THE CITY OF WALTHAM
MASSACHUSETTS
PURCHASING DEPARTMENT
DESIGN, EXTERIOR CITY HALL

ADDENDUM NO. 2

Sept. 15, 2017

11/14/2014

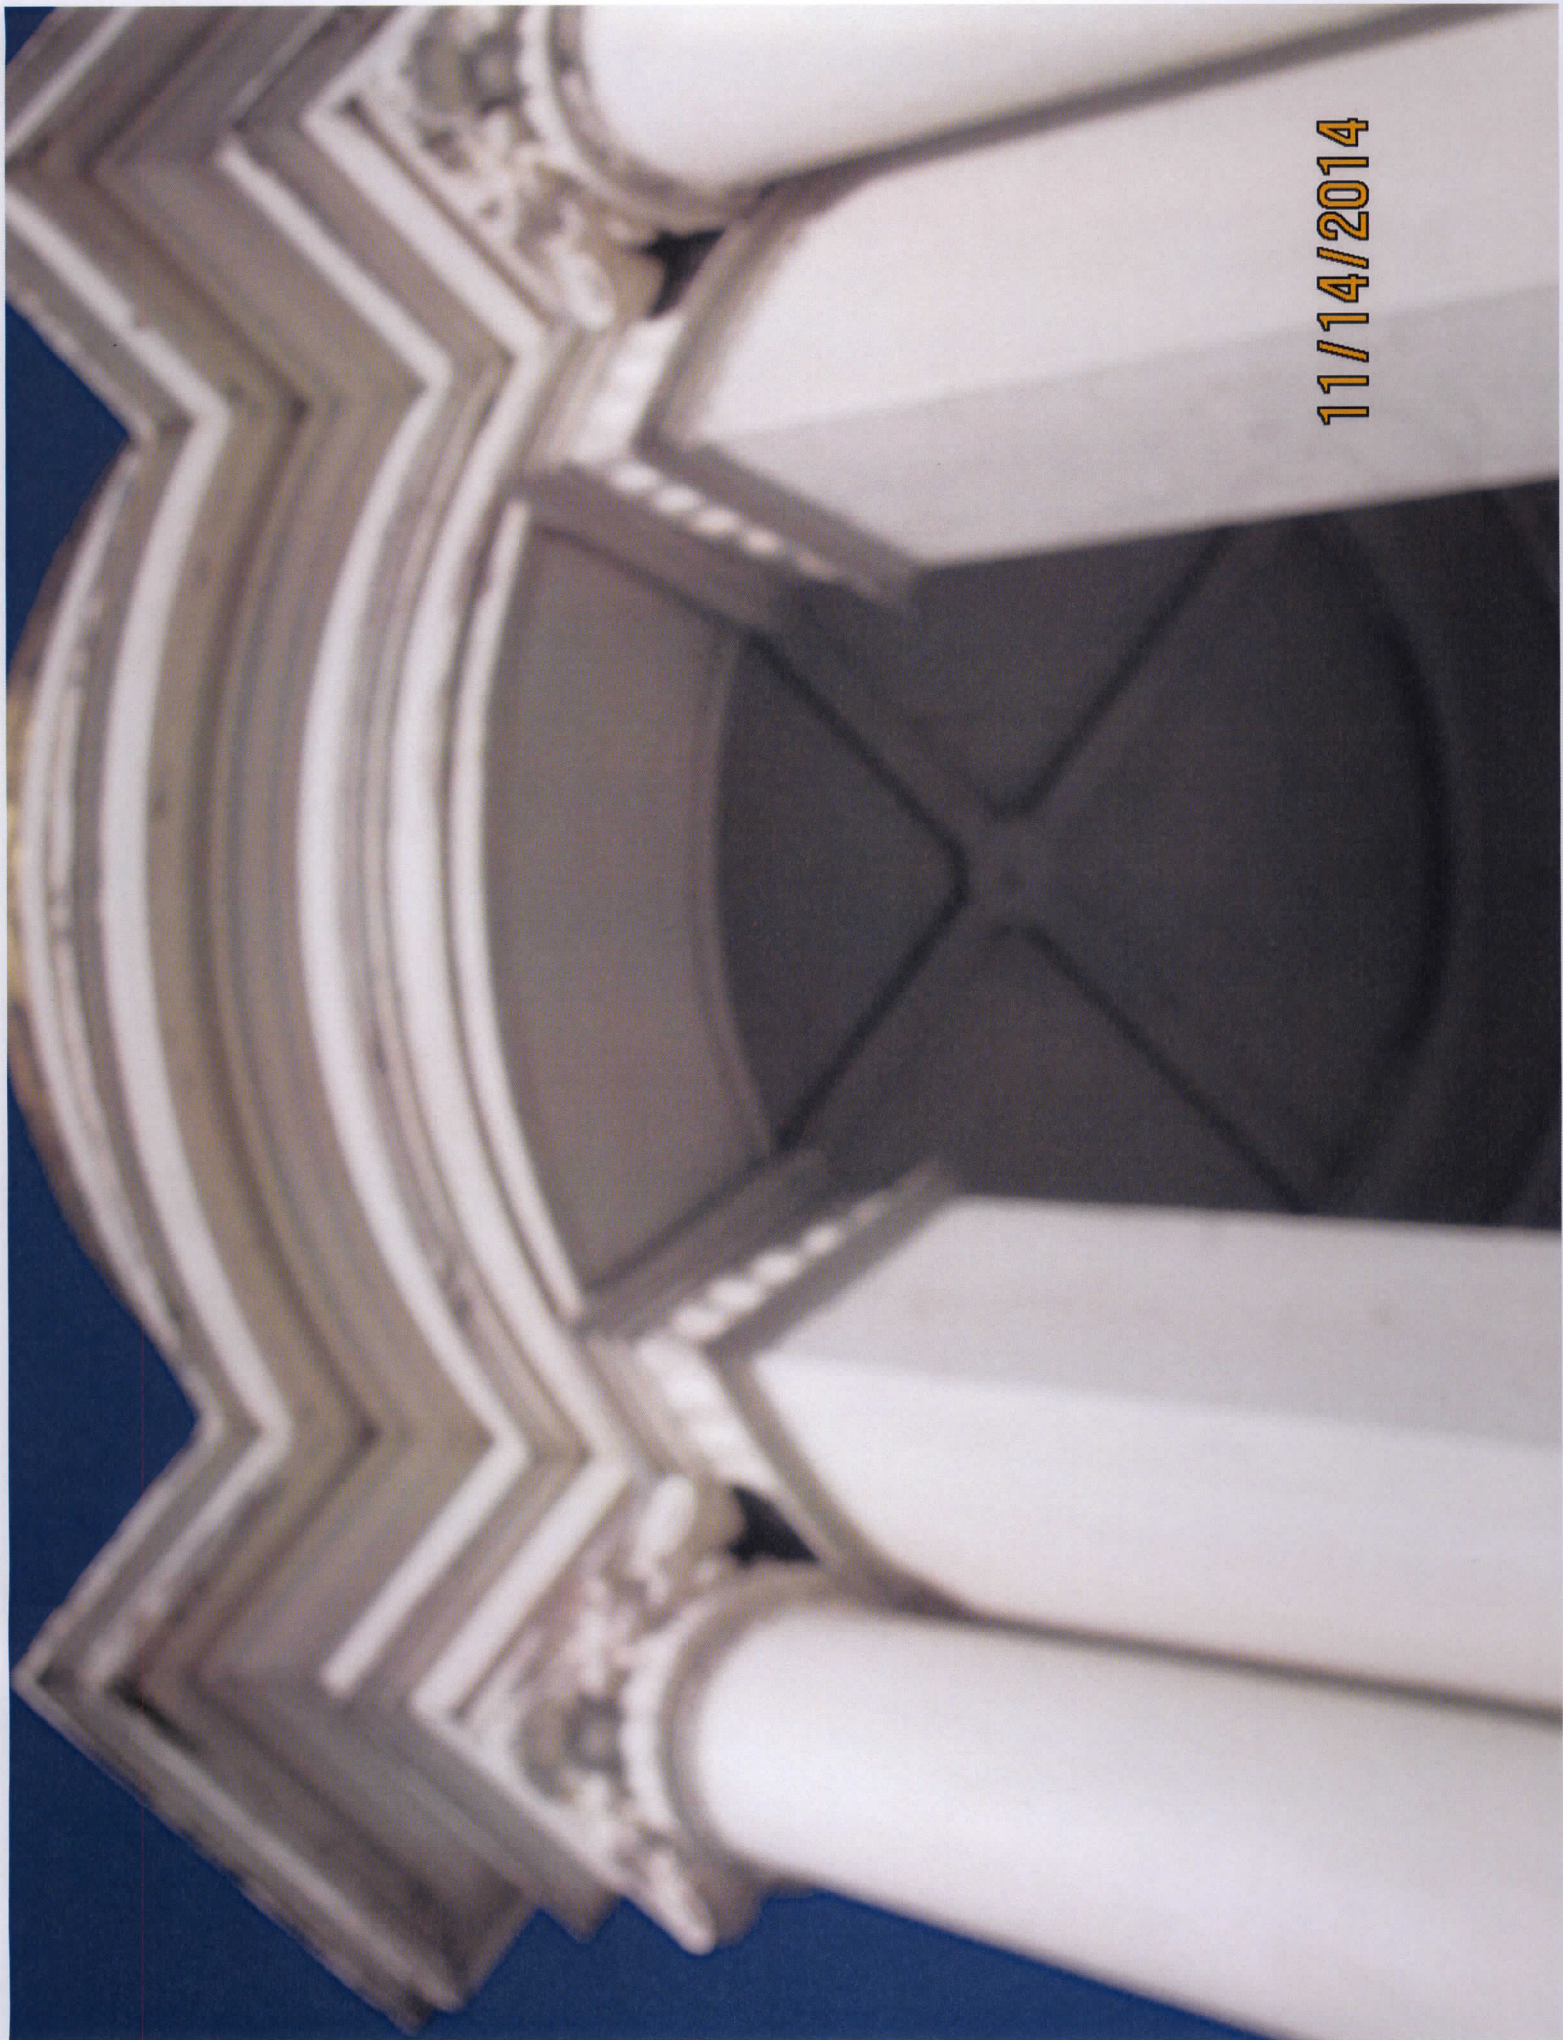
Question 4: Should access lift cost(s) be considered supplemental additional expense(s)?

Answer: The designer shall determine the need for the lift and absorb the cost. Also see the following dome pictures
